# LED Platinen und mini Verteiler mit Duplikate Funktion.

Arduino_fuer_LEDs_DCC_1.8

Sheet: 2/2

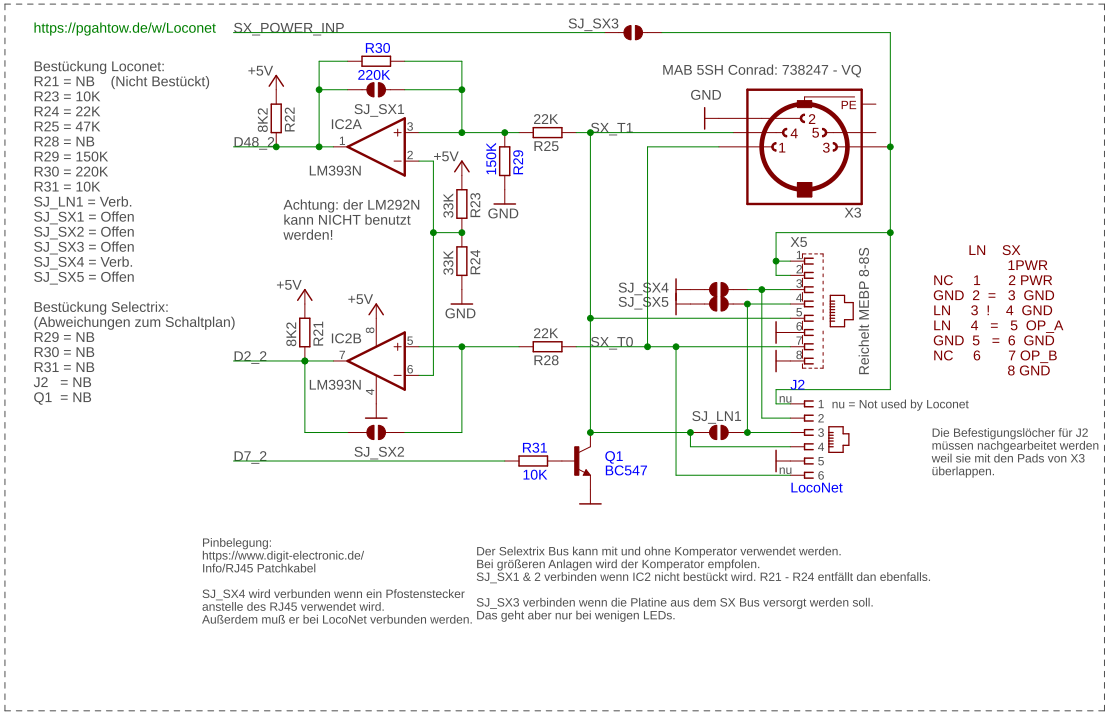
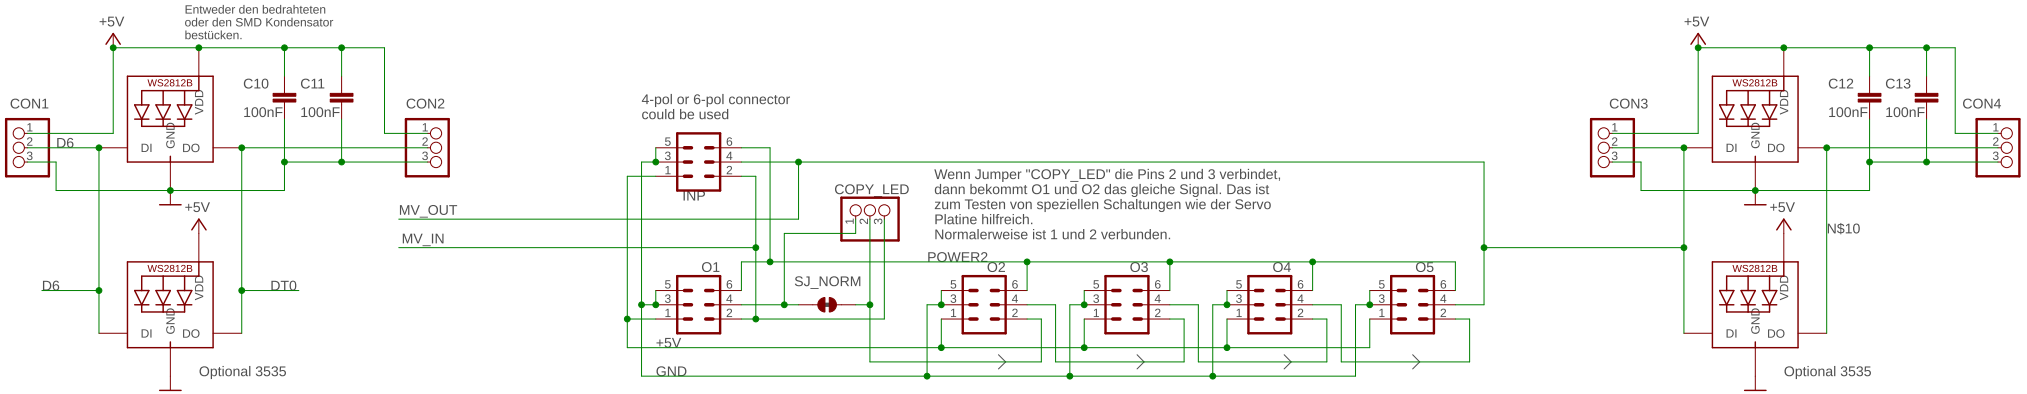
Revision History:
31.08.20: - Corrected the LED PCBs (Ver. 1.5 was totaly wrong)
- swaped the Input/Output pins (3-Pin header = Input)
- corrected the pin assignement of the 3535 WS2812
18.10.20: - Corrected the output of the last connector
31.10.22: - New size of te LED modules
- Additional normaly colosed Solder Jumper
05.11.22: - Moved the Selectrix part to this sheet
- Added Loconet components
